SOLICITATION AMENDMENT
MODIFICATION DE L'INVITATION

Title - Sujet Close Circuit Video Equip. (CCVE)	
Solicitation No. - N° de l'invitation M2989-105860/B	Amendment No. - N° modif. 003
Client Reference No. - N° de référence du client M2989-105860	Date 2012-06-01
GETS Reference No. - N° de référence de SEAG PW-\$VAN-532-6660	
File No. - N° de dossier VAN-0-32508 (532)	CCC No./N° CCC - FMS No./N° VME
Solicitation Closes - L'invitation prend fin at - à 02:00 PM on - le 2012-06-22	
F.O.B. - F.A.B. Plant-Usine: <input type="checkbox"/> Destination: <input checked="" type="checkbox"/> Other-Autre: <input type="checkbox"/>	
Address Enquiries to: - Adresser toutes questions à: Takasaki, Alan H.	Buyer Id - Id de l'acheteur van532
Telephone No. - N° de téléphone (604) 775-7605 ()	FAX No. - N° de FAX (604) 775-7526
Destination - of Goods, Services, and Construction: Destination - des biens, services et construction:

The following questions and answers are for clarification purposes only.

Question 1.6

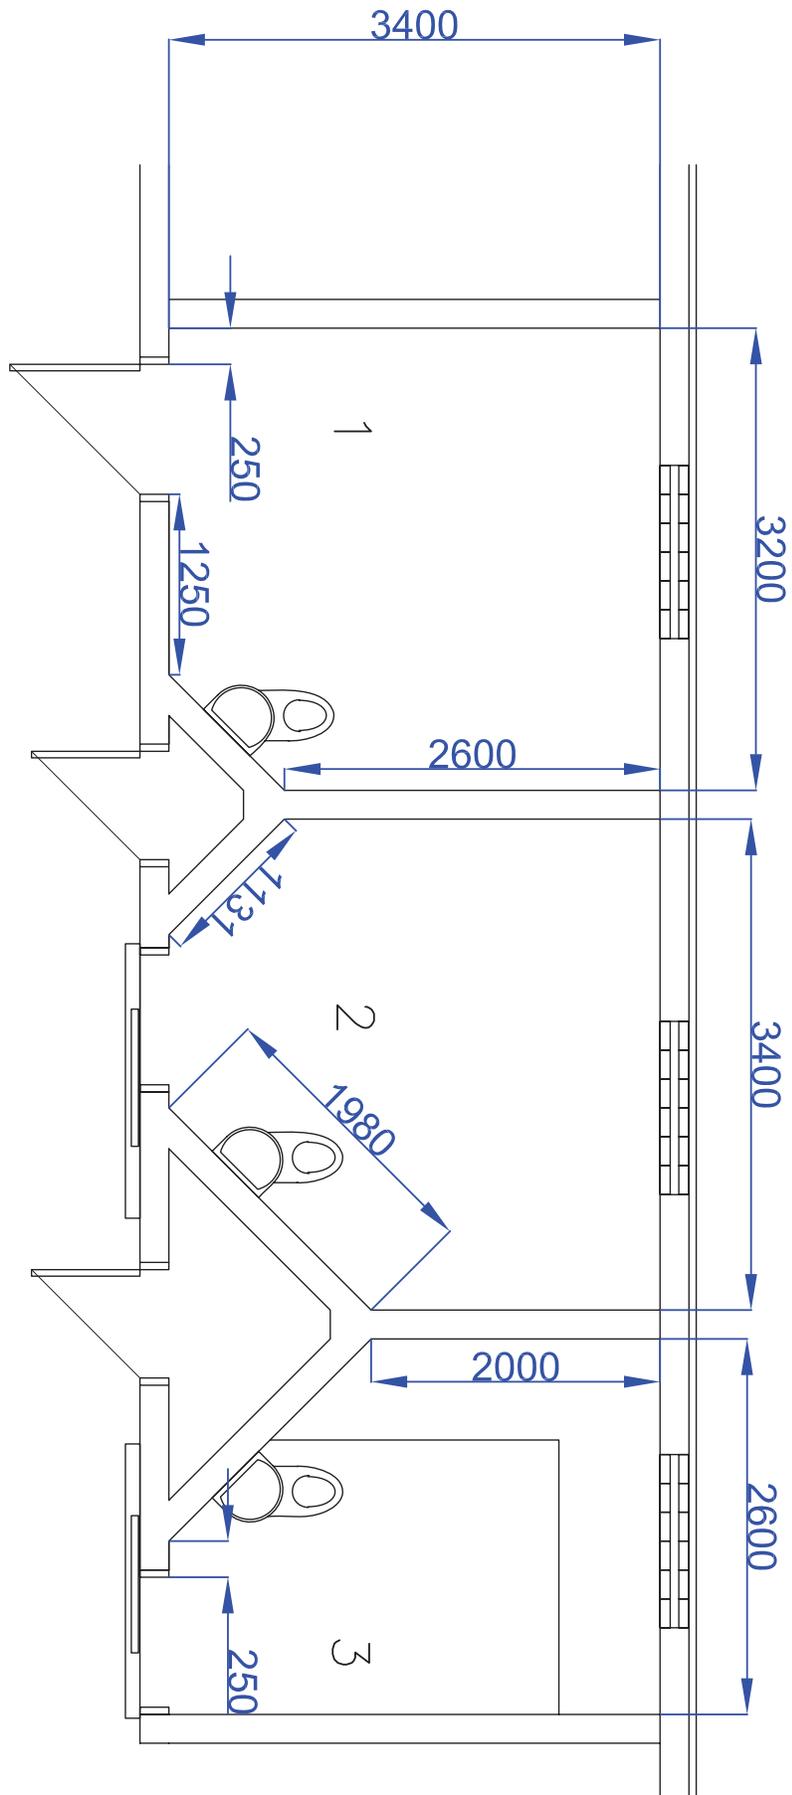
Could PWGSC please provide a copy of the Cell drawing in CADD format?

A .pdf cell drawing is attached. A CADD formatted cell drawing will be only provided on request by emailing, subject line should read “CADD Drawing – CCVE M2989-105860/B”
